Answers to Review Questions

Estimated CDF Data Volume vs Delivered Luminosity

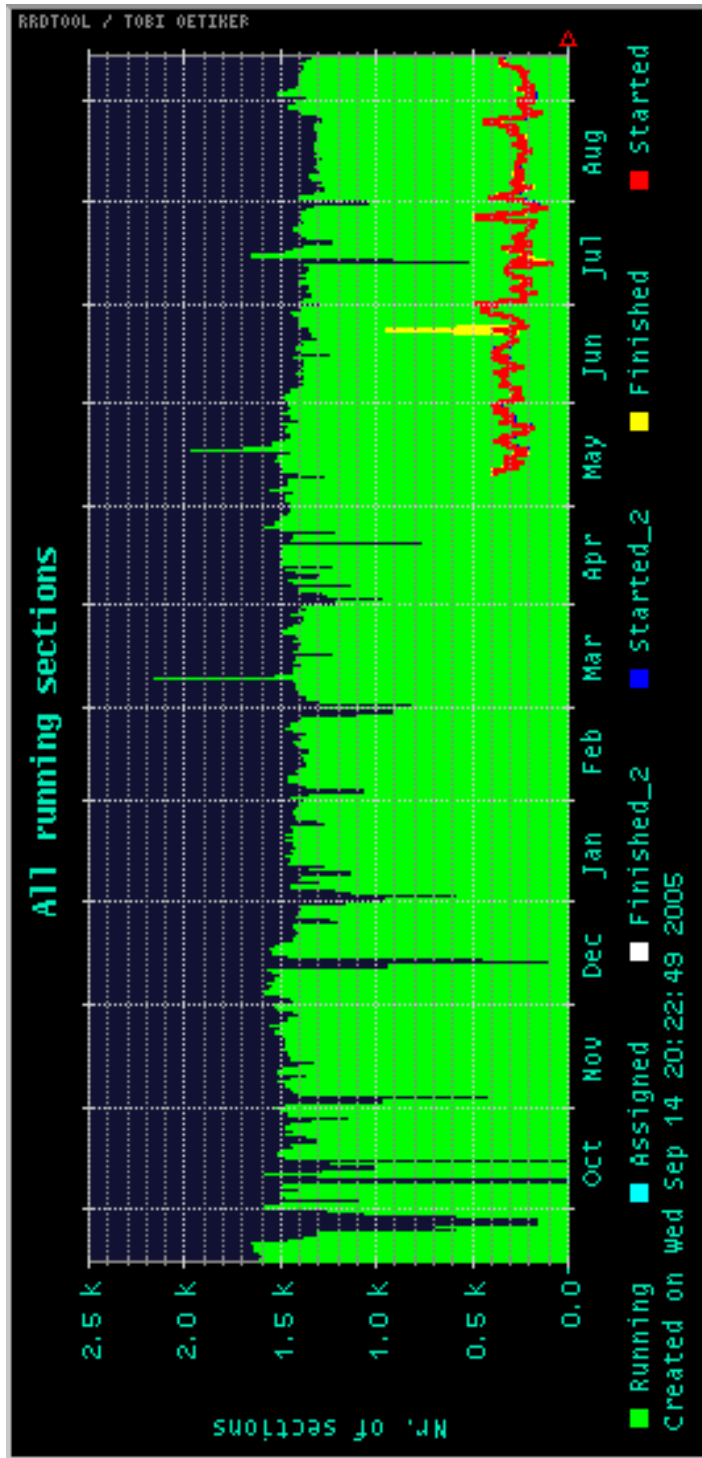
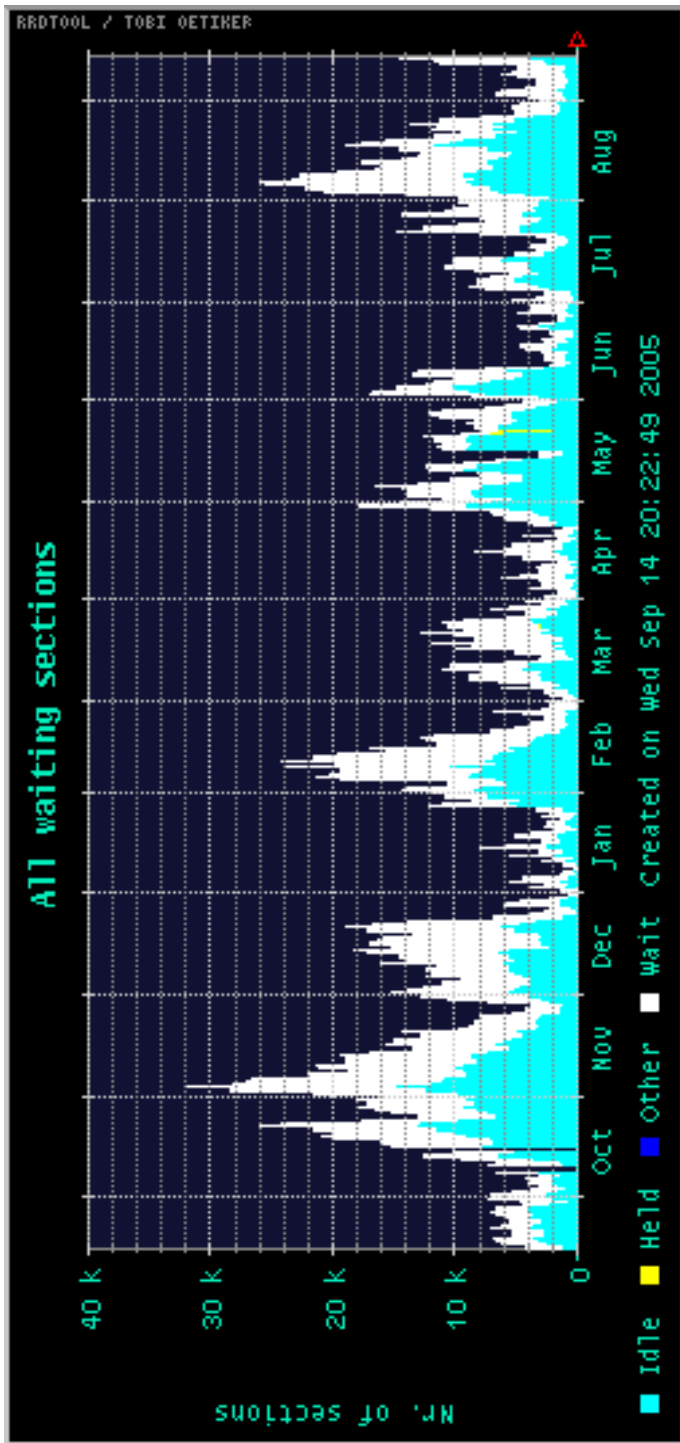
- Question 1: CDF computing model – can you explain the assumptions that go into this plot? If the data rate is determined by trigger bandwidth, we don't understand the plot.
- Answer: We have revised the plot by scaling dataset size with average logging rate -
 - 2004 30 Hz
 - 2005 60 Hz
 - 2006 120 Hz
 - 2007 120 Hz
 - 2008 120 Hz
